FOR PERCOLATION TESTING AND SITE EVALUATION

RE: PERCOLATION TEST RESULTS, A-526698

SEPTIC SPECIFICATIONS WORK-SHEET

2400 Thompson Drive, Marriottsville Percolation Certification Plan and Site Plan

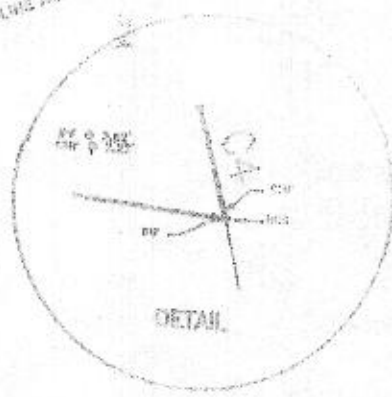
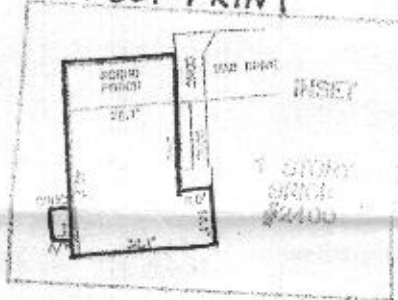
Please add this Note:

Prior to Building Permit application approval, the septic tank capacity will be increased to 2000 gallons, and a trench will be added to the drainfield ~~so~~ Total ~~accomodate flow~~ absorption area will accomodate flow for 5 bedroom residence.

LOCATION: Install 1,000 gallon Septic Tank in tandem with existing 1000 gallon tank.

Install a Trench, 52 feet length, between existing trench and back property line.

ADDITIONAL NOTES: Replumb ~~Dist~~ Existing Distribution Box as necessary.

Call ~~for~~ 1 day in advance of Layout inspection.
Lengthen trench if gravity flow to 2' inlet cannot be achieved.
